RE: Port City Glass Permit Application; 50 India Street, Portland, ME (28-P-15)
DSC Project No. 2012-141

At your request, Downeast Structural Consultants, LLC performed a Limited Structural review of the Dormer Roof Framing at the Port City Glass Building located at 50 India Street in Portland, Maine on December 3, 2012. This report has been prepared based on that review.

<p data-bbox="786 814 1003 898">Dormer Roof Framing (TYP)</p>	<p><u>Building Location:</u> Port City Glass 50 India St, Portland, ME</p> <p><u>Photo Taken By:</u> Christopher Ray, P.E.</p> <p><u>Date:</u> December 3, 2012</p> <p><u>Description:</u> Dormer Roof Framing.</p>
		<p>Number 3.</p>

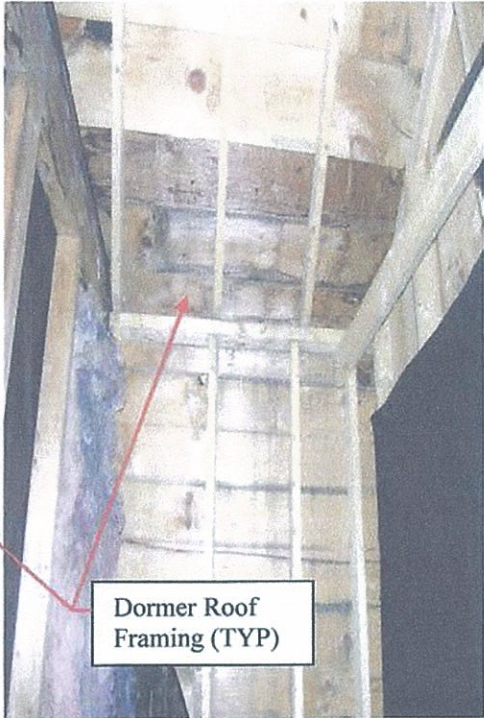
Based on our review, the dormers appear adequately constructed and do not adversely affect the roof framing or adversely affect the overall structural integrity of the building.

<p data-bbox="786 1682 1003 1766">Balcony Framing (TYP)</p>	<p><u>Building Location:</u> Port City Glass 50 India St, Portland, ME</p> <p><u>Photo Taken By:</u> Christopher Ray, P.E.</p> <p><u>Date:</u> December 3, 2012</p> <p><u>Description:</u> Balcony Framing.</p>	
		<p>Number 4.</p>

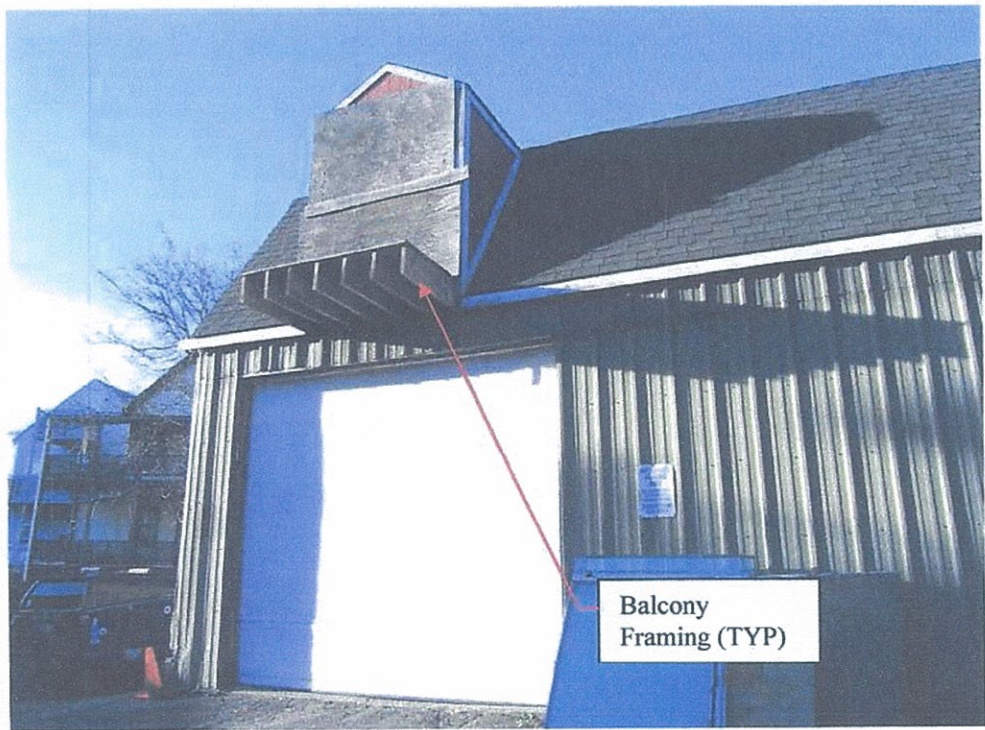
The unfinished balcony appears dilapidated and in poor condition. We recommend dismantling this structure immediately.

1. *We recommend removal of the wood balcony at the rear of the building (Refer to Photo 4).*
2. *Provide (2) 8x8 Composite Wood or Steel Columns at Garage Bay/Workshop Area at Third-Points along existing steel beam length. Provide column cap connection to existing steel beam above and column base connection to 1/2-inch steel plate below.*
